RESPONSE TO DP&E REQUEST FOR ADDITIONAL INFORMATION - MOD 1 TO MP09_0146 EASTLAKES SHOPPING CENTRE

This letter has been prepared by Urbis on behalf of Stateland East Unit Trust (The Applicant) regarding MP09_0146 Mod 1 – Modification to Eastlakes Shopping Centre Mixed Use Development.

Figure 3 – Section of Eastern Laneway Boundary Wall

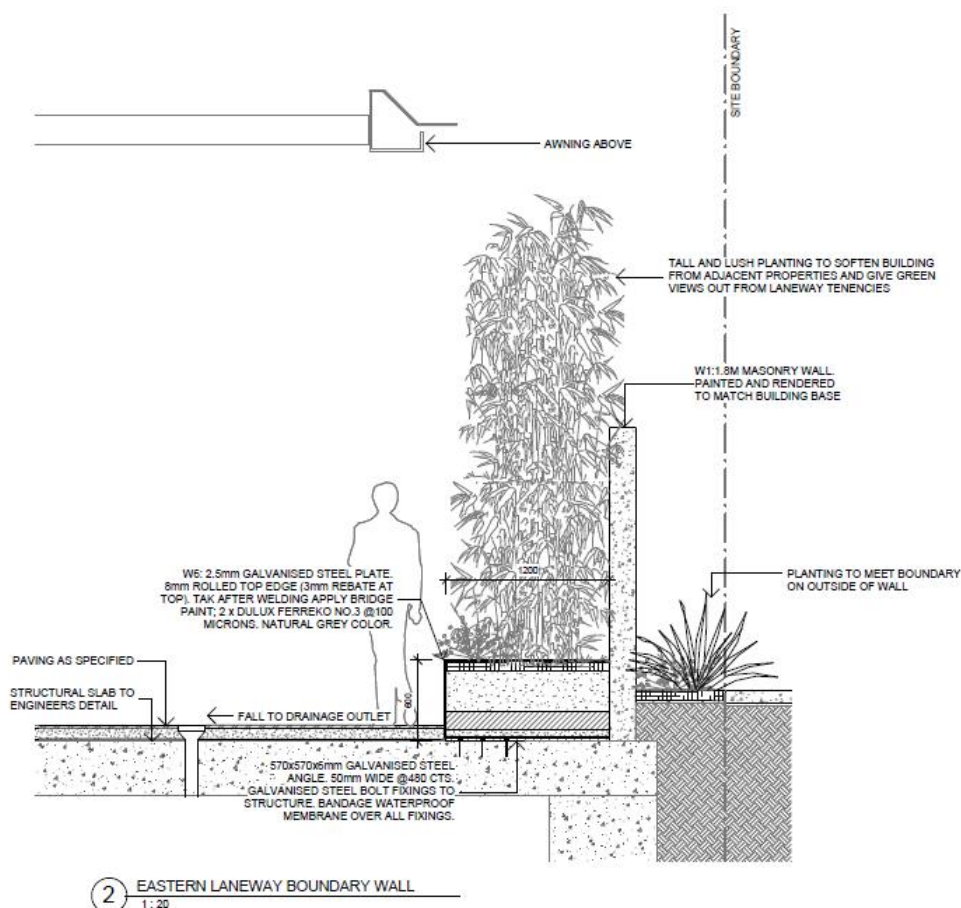
1. *The proposed landscape plans significantly reduce the width of the landscaped setbacks and the extent of plantings, along both boundaries at the ground and podium levels. These changes, including conversion of areas from landscaping to egress/access paths on both sides, are not supported as they would impact on the amenity of adjoining properties. This was a key issue in the assessment of the original application and is contrary to the intentions of modifications B2 and B5.*

In response to DP&E comments, a landscape strip has been incorporated into the revised proposal. This landscaping sits on either side of a 1.8m high masonry wall which is proposed close to the boundary in order to ameliorate noise and privacy impacts to the neighbouring residents. This wall adjoins the neighbouring building's vehicular driveway, with the neighbouring building setback further to the east with limited window openings and open space areas along the western elevation at ground level. This means it will have limited visual impacts on the neighbouring property.

Given the above, the proposed secondary pedestrian entry is considered acceptable. As illustrated in **Figure 3**, the landscaped strip comprises suitable species to soften the wall's appearance and give green views out when viewed from the driveway, generally consistent with the approval.

Figure 4 – Prevailing Built Edge Character and Setbacks to Gardeners Road

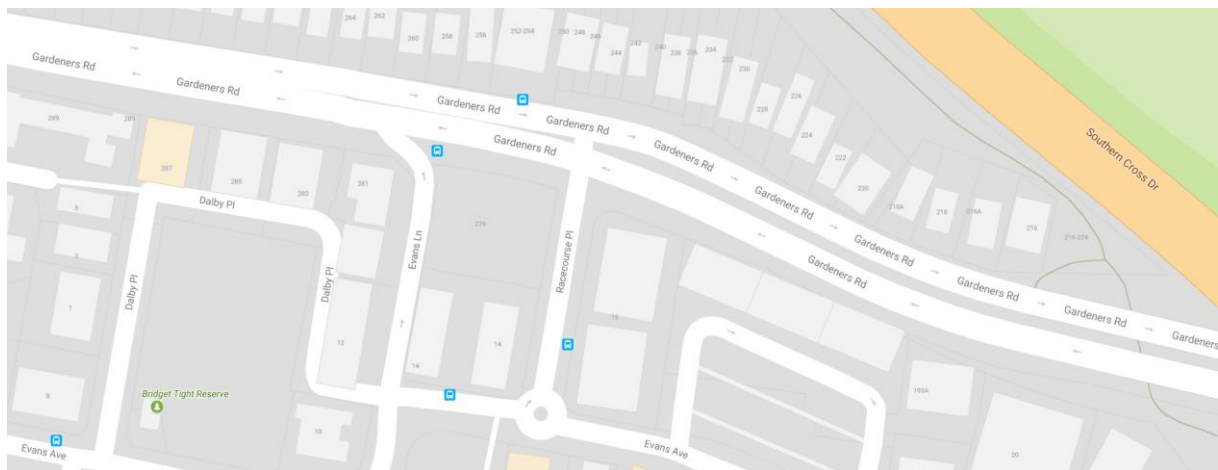
2. *The proposal to extend the ground floor footprint to the boundary results in an unbroken wall up to 6 metres in height, next to the pedestrian footpath. This would result in an adverse urban design outcome, with a significant increase in bulk, loss of landscaping and adverse visual impacts.*

The proposal directly fronts Gardeners Road which is a six-lane arterial roadway that carries large volumes of traffic. The proposal has no entrances or active retail uses fronting this elevation, and this is generally consistent with the remainder of the streetscape. It is therefore not considered that Gardeners Road is conducive to high pedestrian traffic as it does not provide a high level of amenity.

In addition, the prevailing built edge character and building setbacks to Gardeners Road is generally built to the boundary (see **Figure 4**).

Figure 7 – Ground Level Landscape Plan

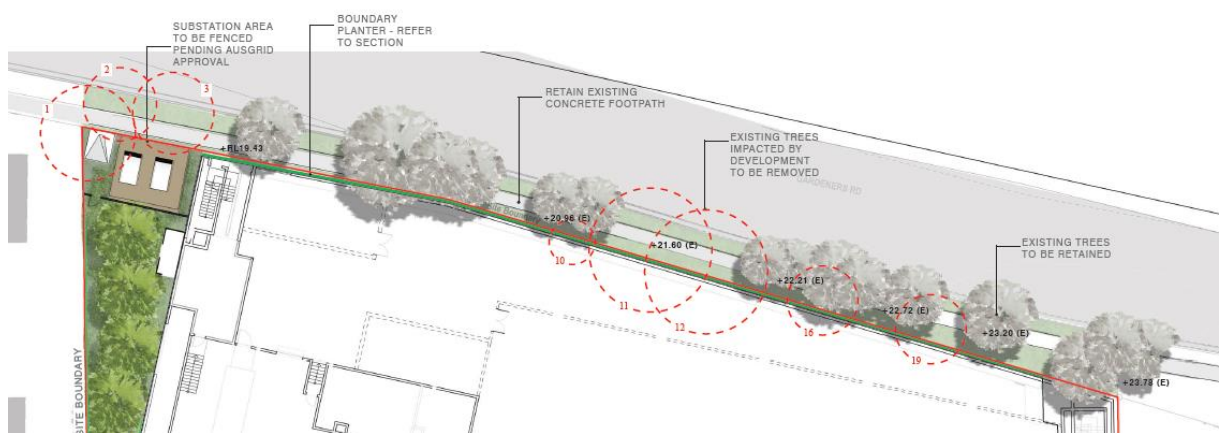
3. The proposed change also results in the loss of significant street trees not previously proposed for removal. There has been no assessment or justification for the loss of these trees. The application as submitted only sought removal of street trees in Evans Avenue.

The proposed modification to the retail footprint results in the removal of 5-existing street trees along Gardeners Road. An additional 2-existing street trees are also required to be removed along this elevation due to proximity to building services and site infrastructure in the north-western corner (refer to **Figure 7**). Note: Tree 1 has already been approved for removal under the existing approval.

The Arboricultural Report prepared by Ecological Australia (submitted at Appendix E of the modification application) provided an assessment of Trees 11 & 12. The trees are classified as *eucalyptus microcorys* species and have a medium retention value. The report concludes that the two trees cannot be retained on the site as the proposed works result in a 'major encroachment' into the tree protection zone. The report recommends that the trees are replaced with suitable species in accordance with the *Botany Bay Street Tree Masterplan 2014*. It is proposed that replacement planting is conditioned accordingly.

A separate Arboricultural Report prepared by Treescan (submitted at Appendix 11 of the original Part 3A application) provides an assessment of all existing trees across the site. The remainder of the street trees sought for removal are identified as Trees 2,3,10, 16 & 19. These trees are classified in the Report as follows:

- Tree 2 – fair condition but recommended for removal.
- Tree 3 – poor condition; spare crown lopped for power line clearance.
- Tree 10 – poor condition; root system in bank.
- Tree 16 – poor condition; dying.
- Tree 19 – fair condition; weak junction at base.

These trees are not identified as containing any ecological significance and are in fair to poor condition. These trees also provide limited aesthetical contribution to the streetscape and do not form part of any established tree line along Gardeners Road. Removal of these trees is therefore considered acceptable.
